Subject: BLOWER MOTOR STAYS ON AFTER KEY OFF	Bulletin No: 07-003/11
	Last Issued: 05/26/2011

2007-2010 CX-9 built before JM3 TB**** A* 227576 (May 17, 2010)

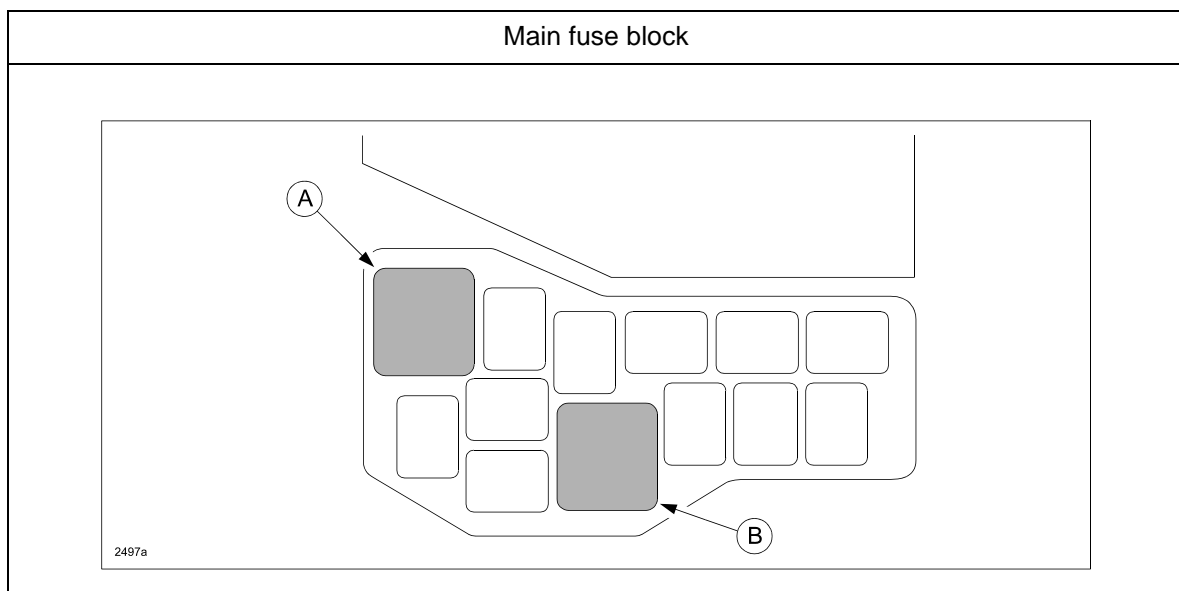
If customer complains about an intermittent front or rear blower motor operation after ignition key is switched to the off position, replace both front (A) and rear (B) blower motor relays.

Part Number	Description	Qty.
L1Y1-67-730	Blower Motor Relay	2
